RE: ER06-683 Enrico Fermi Atomic Power Plant - Potential New Facility, Monroe County (NRC)

RE: ER06-683, Enrico Fermi Atomic Power Plant Project Area Clarification

Response to RAI letter related to Fermi 3 ER

RAI Question CR4.1.3-2

Map 22. NRHP Listed and NRHP Eligible Above-Ground Properties within the Above-Ground Resources Area of Potential Effect

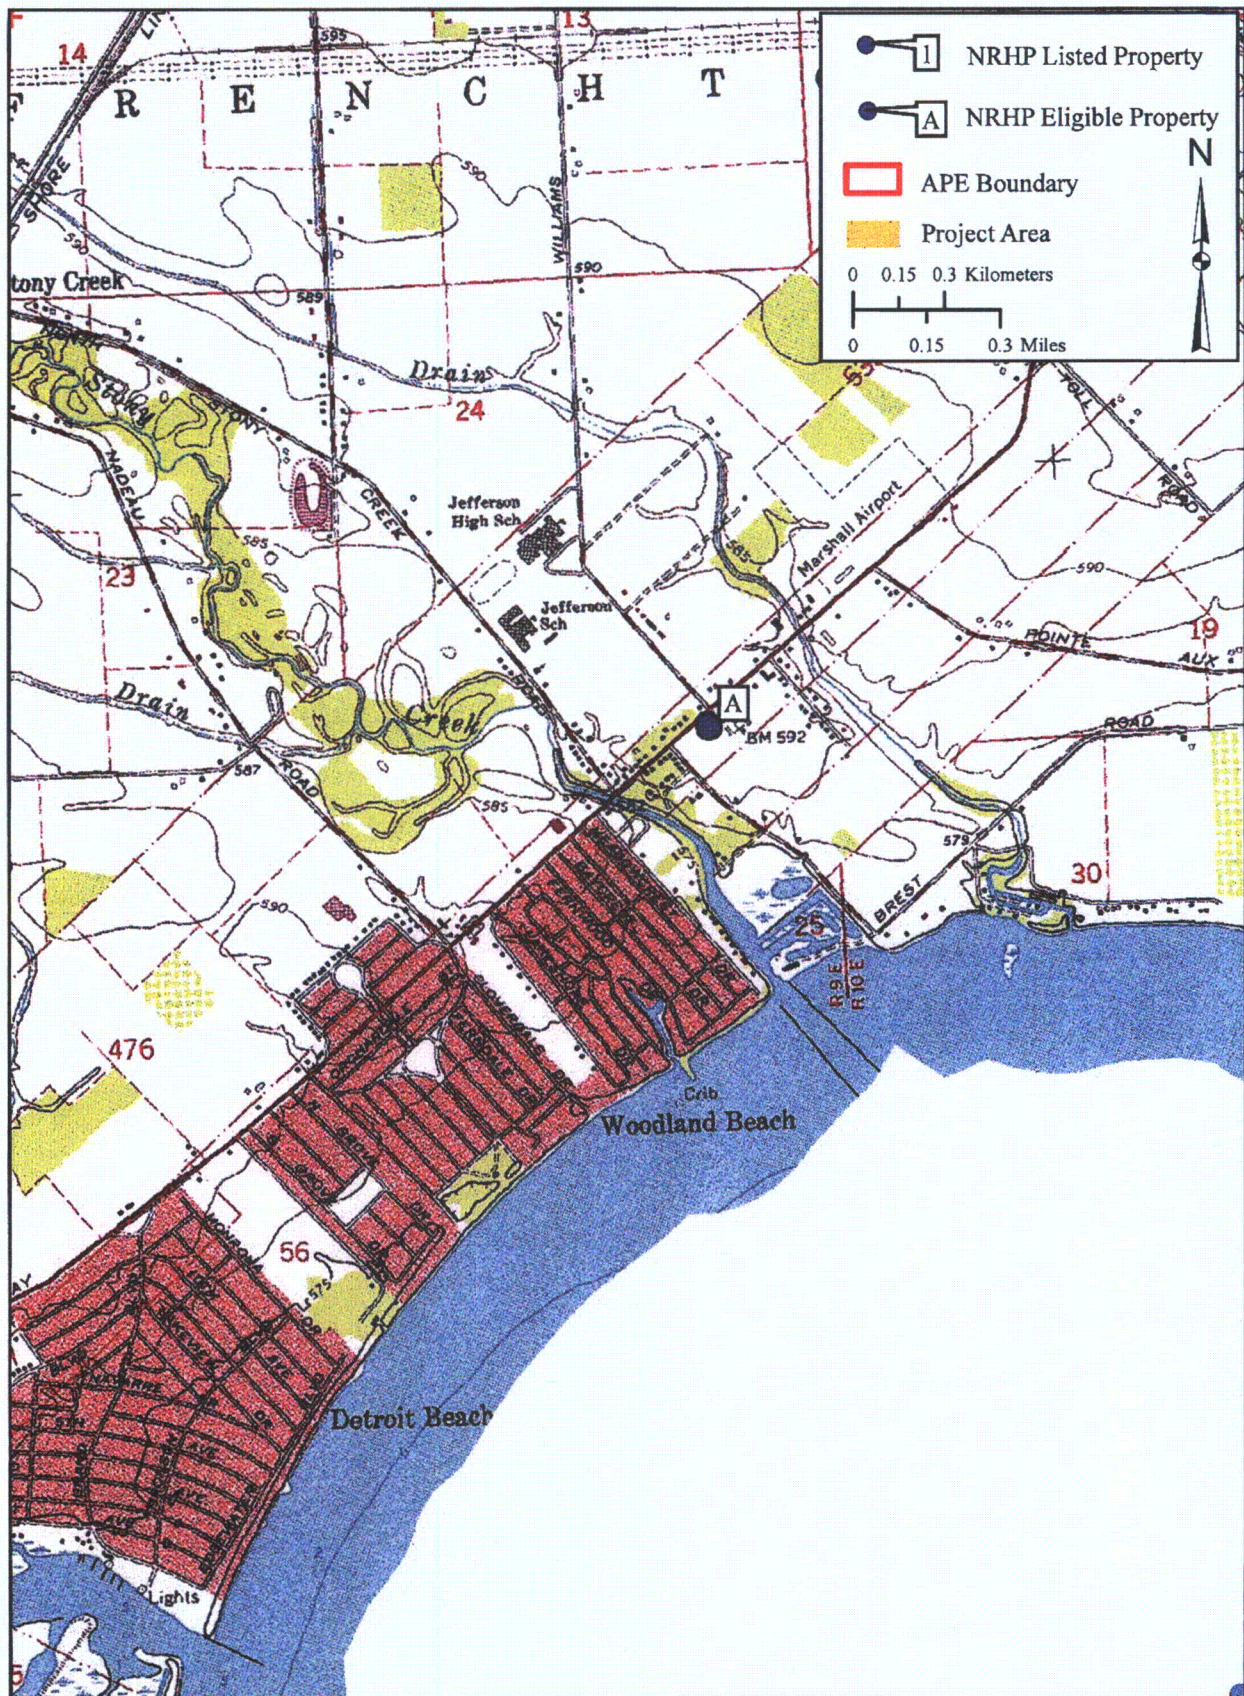
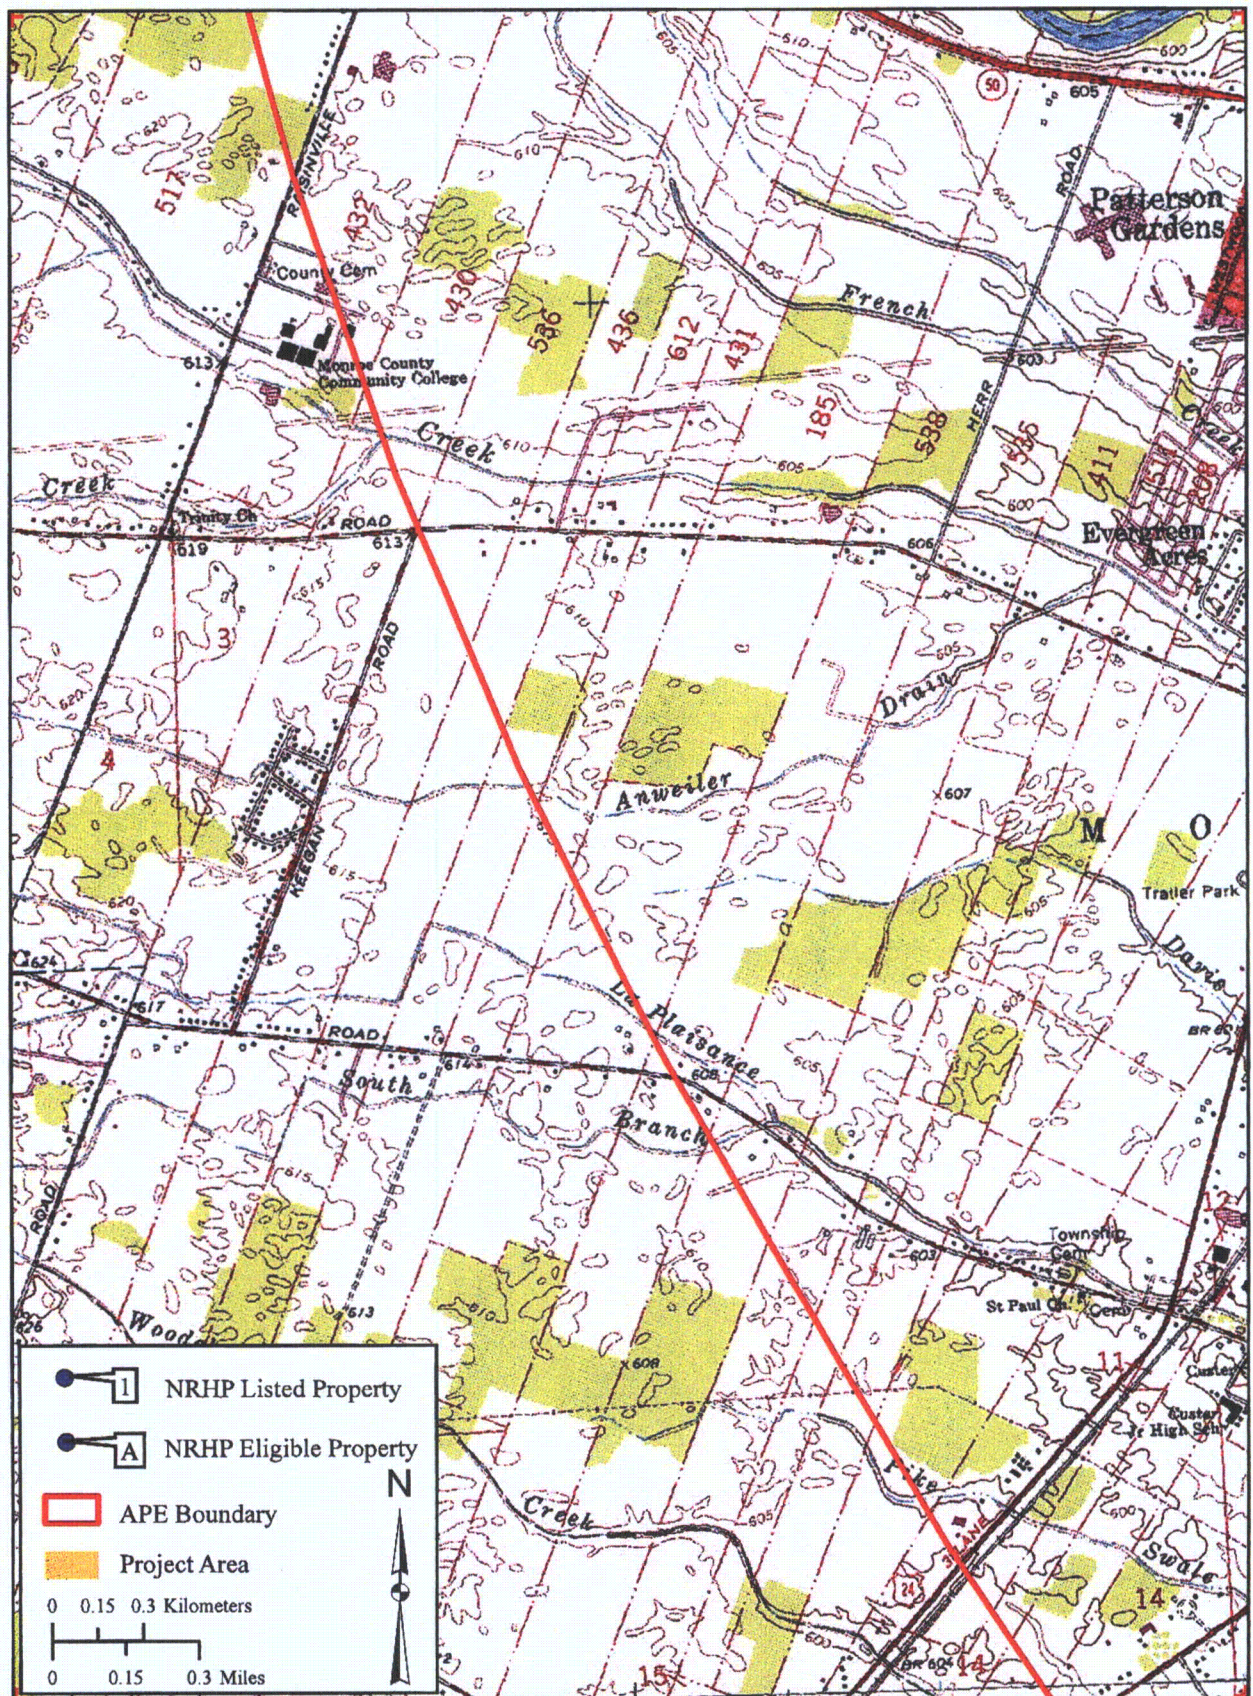
- In addition, the proposed twenty-mile-diameter APE for above-ground resources seems excessive. We suggest a smaller APE that includes the nearest shoreline settlements, from Estral Beach on the northeast to Woodland Beach and Detroit Beach on the southwest. The north boundary for this APE could correspond to Masserant Road and a westerly extension west to North Dixie Highway, the west boundary the North Dixie Highway between Masserant on the north and Sandy Creek on the south, and the south boundary Sandy Creek. In addition, the APE should include the properties fronting on North Dixie Highway's north side and the settlement of Oldport. This area is shown on maps 16, 17, 18, 22, 23, and 24 provided with your letter of September 10.
